CENTRAL ELECTRONICS, INC.

10B CHANGE NOTICE - MODIFICATION "C"
MIXER CIRCUIT CHANGE

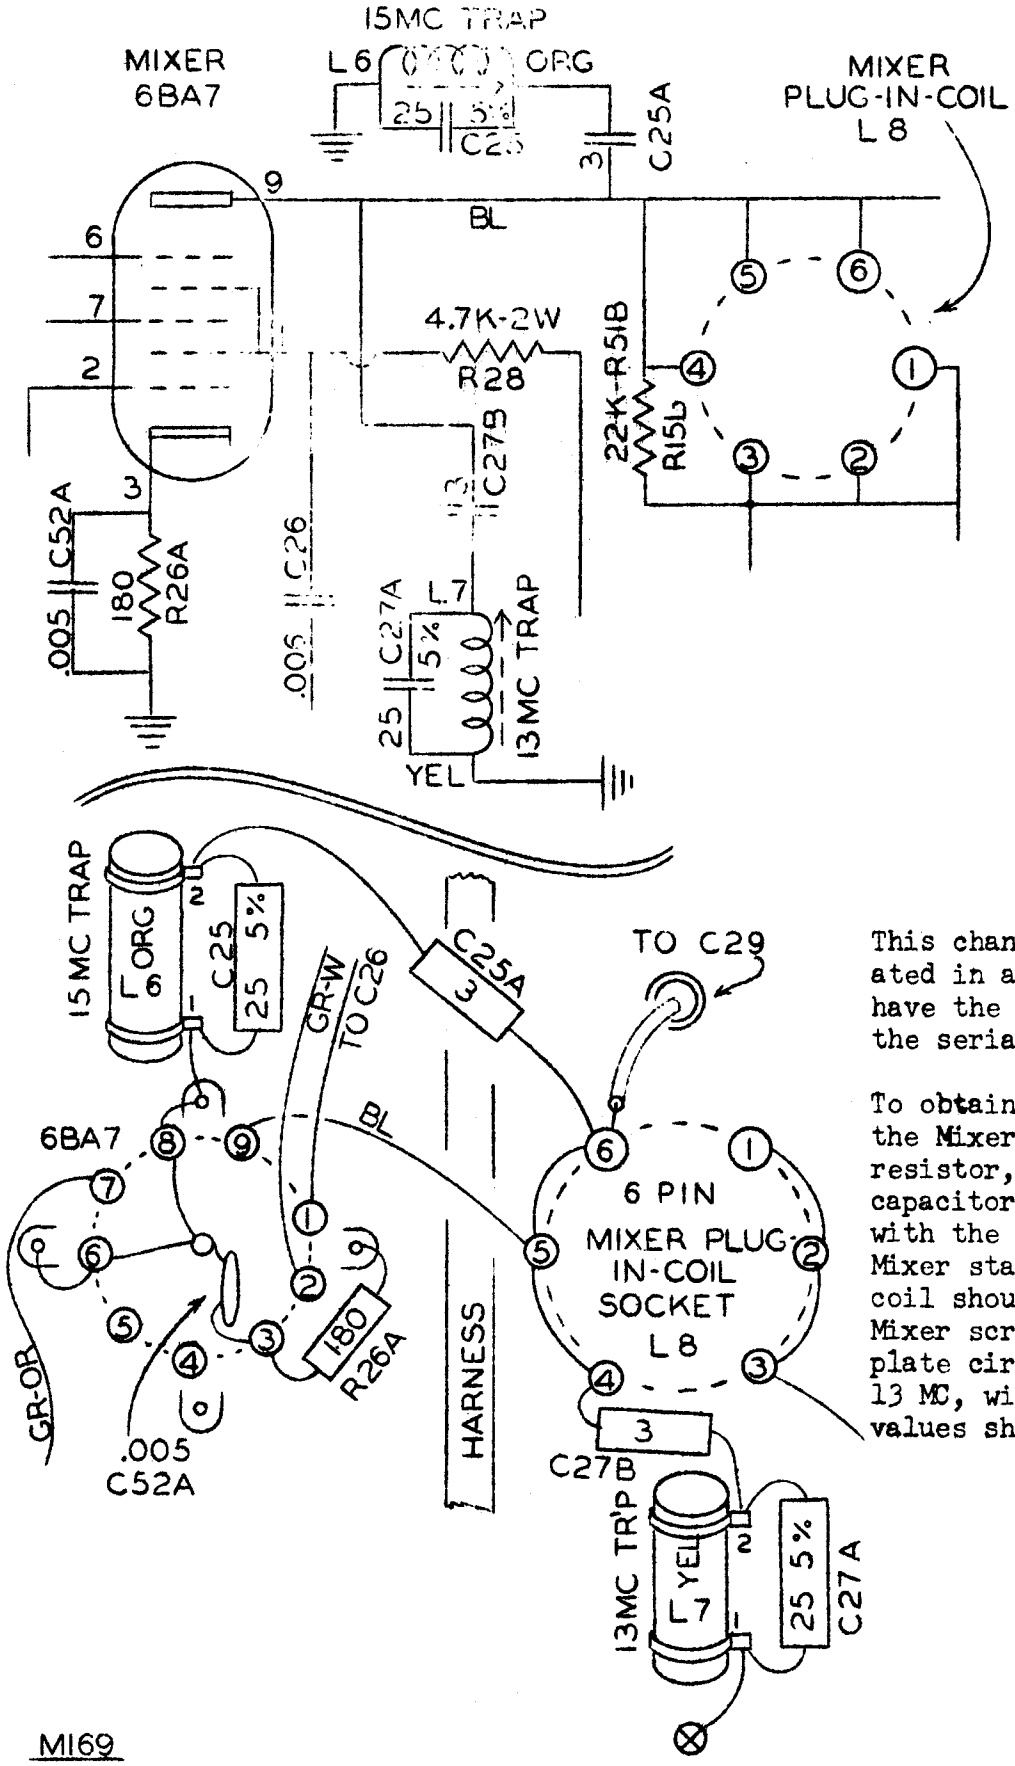
This change has been incorporated in all Exciters which have the letter "C" following the serial number.

To obtain better linearity in the Mixer stage a 180 ohm resistor, bypassed with a .005 capacitor, is used in series with the cathode of the 6BA7 Mixer stage. The yellow trap coil should be moved from the Mixer screen circuit to the plate circuit and tuned to 13 MC, with the new capacitor values shown above.
